Omaha Public Power District
(Fort Calhoun Station
Unit No. 1)

APPLICATION FOR AMENDMENT
OF
OPERATING LICENSE

TABLE 1
COMPARISON OF ORIGINAL AND REVISED INPUTS
FOR THE CYCLE 14 TRANSIENT, T/H AND SETPOINT ANALYSES

Figure
5-2

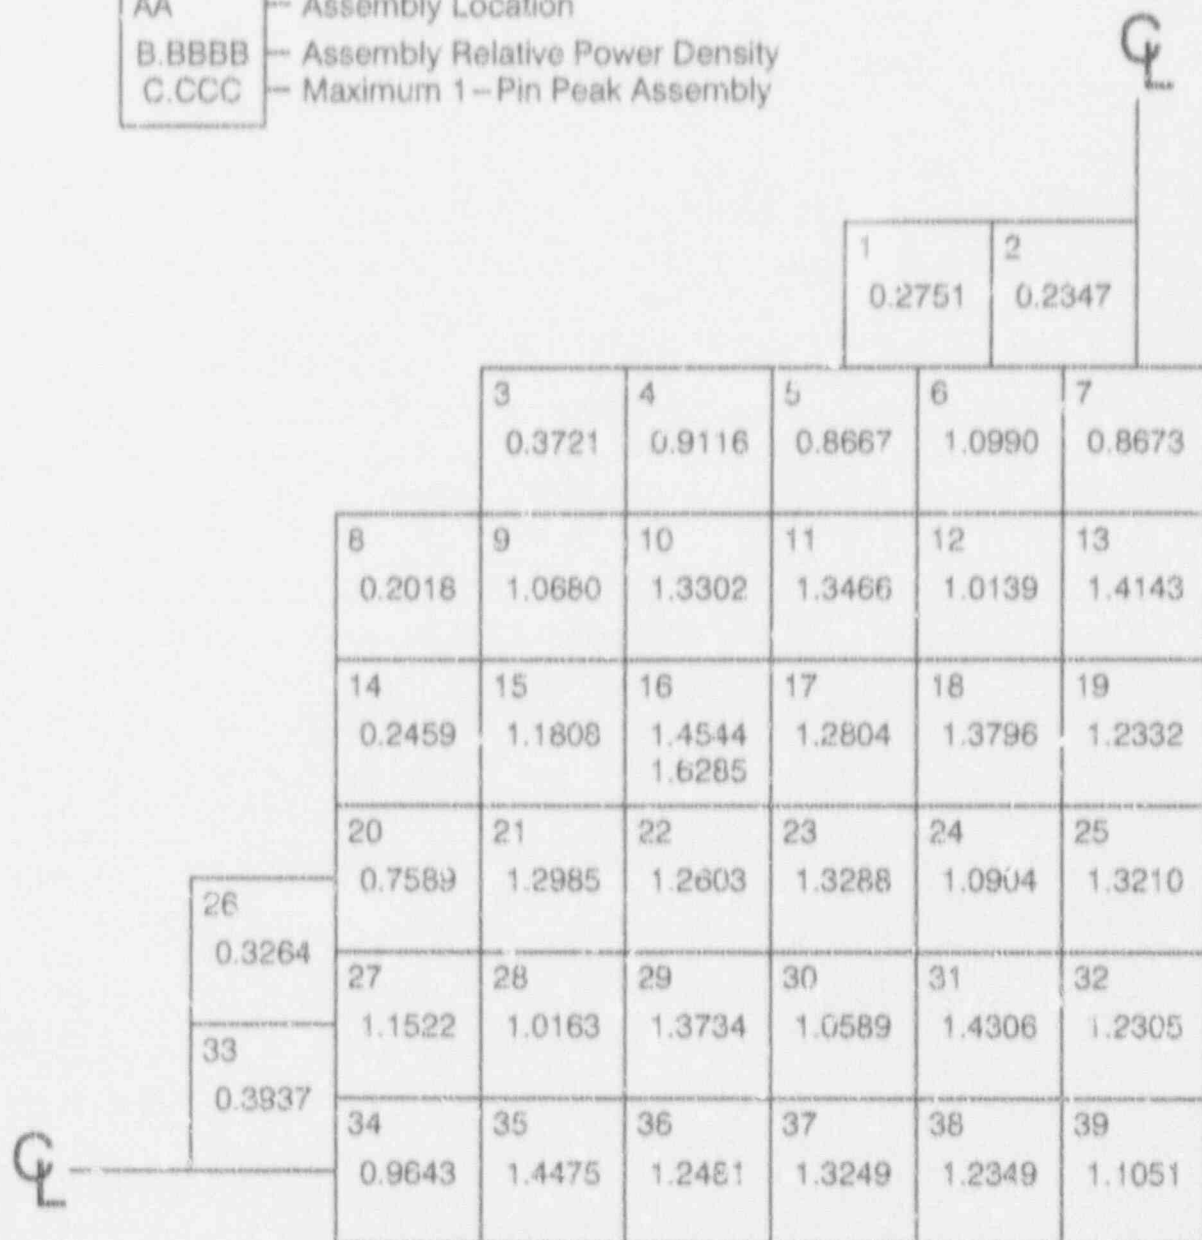
Figures 5-1 through 5-3 illustrate the all rods out (ARO) planar radial power distributions at BOC14, MOC14, and EOC14, respectively, and are based upon the Cycle 13 late window burnup timepoint. These radial power densities are assembly averages representative of the entire core length. The high burnup end of the Cycle 13 shutdown window tends to increase the power peaking in the high power assemblies in the Cycle 14 fuel loading pattern. The radial power distributions, with Bank 4 fully inserted at beginning and end of Cycle 14, are shown in Figures 5-4 and 5-5, respectively.
